## MEMORANDUM

**REVIEW TYPE:** Pre-preliminary Plan of Subdivision (**Advice Only**)

**PROJECT NAME:** Shady Grove Road

**CASE NO.** 720060110

## PRE-PRELIMINARY PLAN

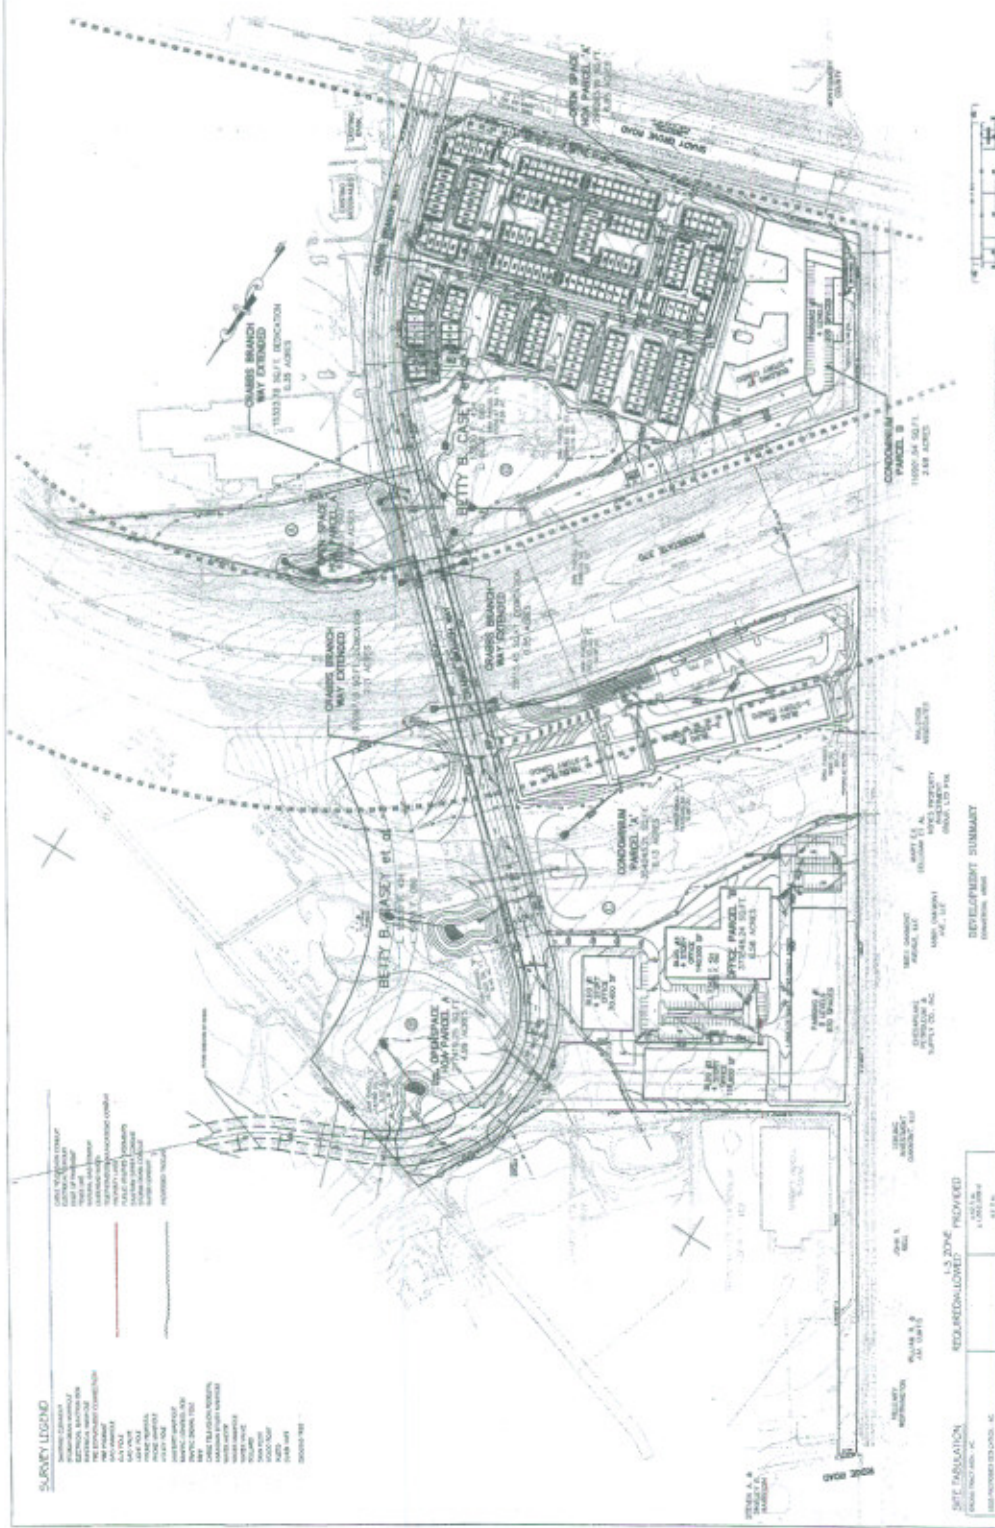
For Casey 6, the base density under the I-3 optional method would be 200 units (25 acres x 8 units/acre); however, the Sector Plan establishes a reduced base density of 130 units due to site constraints. The submitted proposal conforms with the Sector Plan housing recommendation limited to 130 units by providing 55 multi-family units in Buildings 4, 5 and 6 which are three stories high. The common open space (HOA Parcel A) which 4.99 acres in size, is used as stream valley protection and to buffer the development impacts to adjacent residential communities of Washington Grove and Mill Creek. HOA Parcel A contains a stormwater facility that appears to encroach in the stream buffer.

The proposal depicts Crabbs Branch Way as a roadway with 80-foot right-of-way extending to Amity Drive as recommended in the Sector Plan.

The submitted proposal also conforms to the Sector Plan's commercial recommendations by providing office development and structured parking within the Sector Plan limits of 0.3 FAR. The proposal utilizes a three building configuration at 0.2 FAR.

- Reconfigure the design layout to increase the amount of usable open space and reoriented units that benefit from the open space.
- Provide 80 feet right-of-way along Casey 6, minimizing grading in environmental sensitive areas, and providing sidewalk, Class I bikelane and lawn panel.
- Provide 80 feet right-of-way for Casey 7 with sidewalk, Class I bikelane, and lawn panel

- Design stormwater management facility that does not reduce overall density. Utilize underground measures for quantity and quality control.
- Noise study and attenuation measures must be considered in residential development of either parcel and may reduce the requested yield.
